UNITED STATES OF AMERICA  
NUCLEAR REGULATORY COMMISSION

In the Matter of:	)	
	)	Docket No. 70-3103-ML
Louisiana Energy Services, L.P.	)	
	)	ASLBP No. 04-826-01-ML
(National Enrichment Facility)	)

**APPLICANT'S PREFILED TESTIMONY IN MANDATORY HEARING  
CONCERNING MATTERS RELATED TO NUCLEAR CRITICALITY (SAFETY  
MATTER NOS. 5 - 8 AND OCTOBER HEARING QUESTIONS 6.b, 6.e, 6.f, and 6.g)**

Figure 1 Mean Log Energy of Neutron Causing Fission versus H/U Ratio

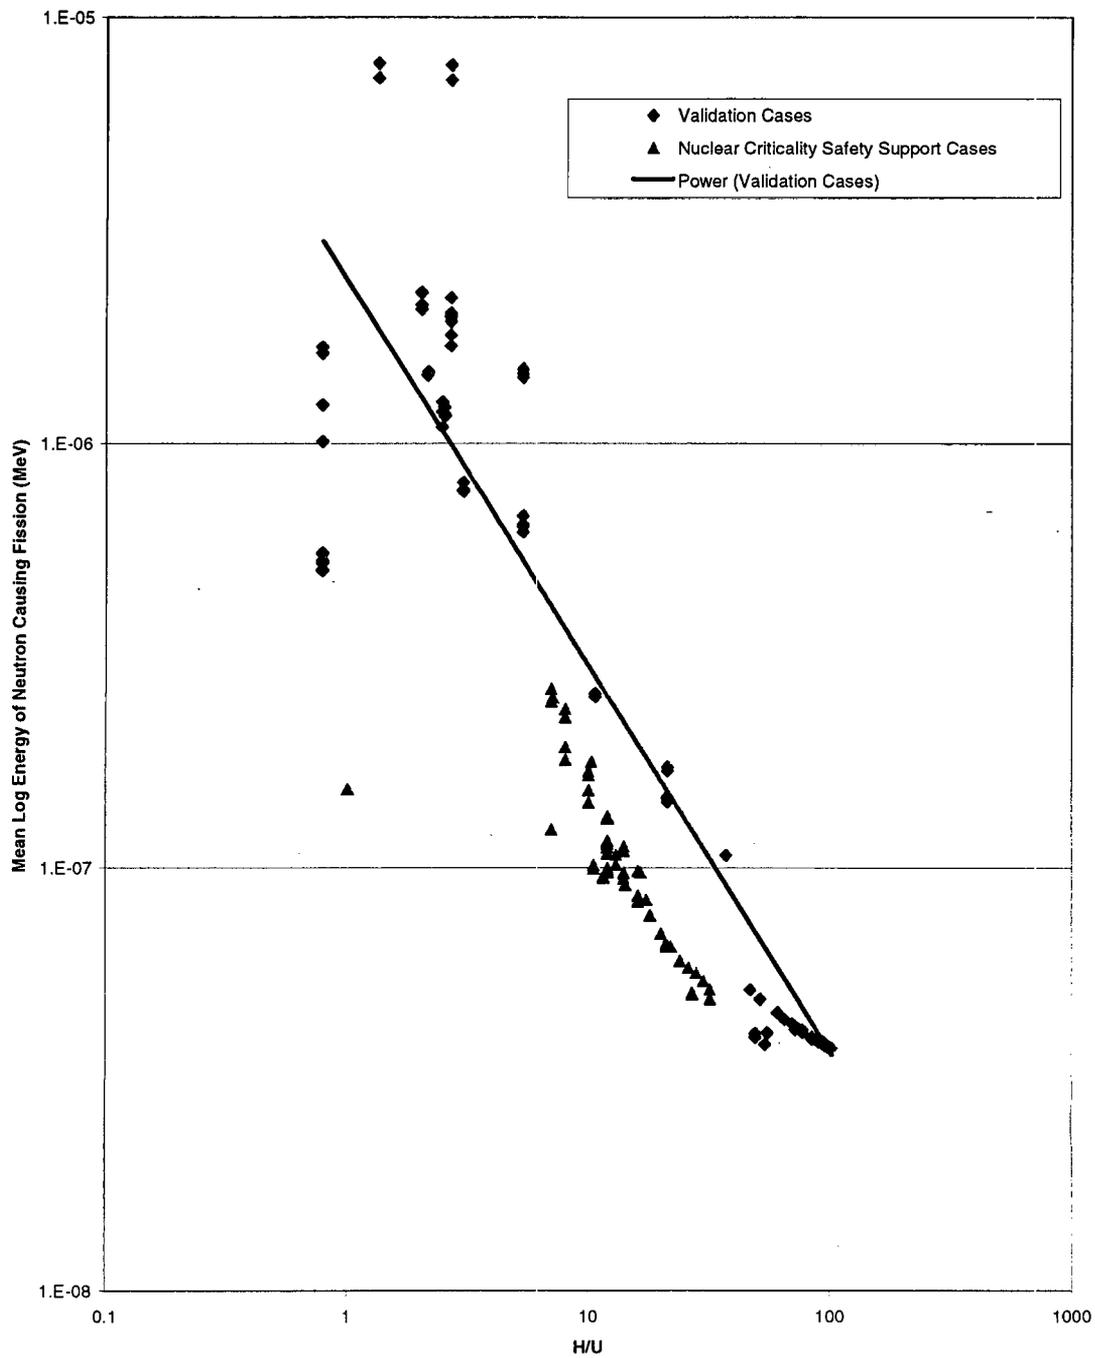
There are some gaps in the H/U ratios in the validation cases that may contribute to the calculated change in bias associated with variance of H/U ratio ranges. Given that the spectrum is primarily controlled by the H/U ratio, the impact of the variance of H/U ratio ranges

on the MONK 8A validation for NEF (*i.e.*, change in bias) can be answered by looking at how well the neutron energy spectrum is covered by the validation cases.

**Figure 1 and Figure 2** ("Validation and NCS Support Analysis Cases k-effective vs Mean Log Energy of Neutrons Causing Fission") below show that the LMENCF for the NEF NCS support analyses cases cover a region of the plot that has some gaps in the validation cases. However, the NEF NCS support analyses cases all fall in an energy region below 1 eV. Neutron cross sections in this energy region vary very little with energy, and are usually well characterized by  $1/v$  behavior. Given the well-behaved cross sections in this energy region, there is no reason to expect a change in bias due to a relatively small change in neutron spectrum. As a result, considering the strong correlation between H/U ratio and neutron energy spectrum, it is expected that the true impact (given sufficient applicable benchmark critical data) of the variance of H/U ratio ranges, for the ranges covered by the NEF NCS support calculation cases, should be insignificant.
